TASK NO.	TASK/DESCRIPTION	NOTES
H2.11	<p data-bbox="400 327 1150 383">H2 HULL AND STRUCTURE – EXTERNAL DECKS AND ASSOCIATED FITTINGS</p> <p data-bbox="400 416 512 450">02 Deck</p> <div data-bbox="400 465 1107 1070">  </div> <p data-bbox="400 1084 1214 1173">Port and stbd 02 deck waist decks have had deck screeding removed and are heavily corroded. Decks to be REPRESENTED with non slip paint coating.</p> <p data-bbox="400 1182 847 1211">ALLOW for 80m² REPRESENTATION.</p>	<p data-bbox="1249 421 1401 562">IAW Paint scheme - General 12 and Annex B refer.</p> <p data-bbox="1249 591 1449 674">To be completed in conjunction with H3.04.</p>

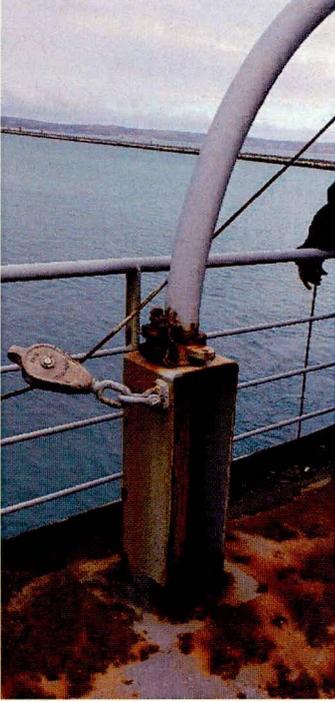
TASK NO.	TASK/DESCRIPTION	NOTES
H2.10	<p data-bbox="408 416 967 450">Redundant Accommodation Ladder Davit</p>  <p data-bbox="408 1182 1214 1294">Active corrosion and paint coating breakdown at base of redundant accommodation ladder davit. Davit no longer used therefore davit to be REMOVED and deck area REPRESENTED. Contractor to dispose of all removed materials on completion.</p> <p data-bbox="408 1312 836 1339">ALLOW for 1m² REPRESENTATION.</p>	<p data-bbox="1254 423 1452 591">Hotwork Required – Appropriate precautions to be taken in accordance with General 8.4.</p> <p data-bbox="1254 622 1406 734">To be completed in conjunction with H2.17</p> <p data-bbox="1254 766 1401 902">I/AW Paint scheme - General 12 and Annex B refer.</p>
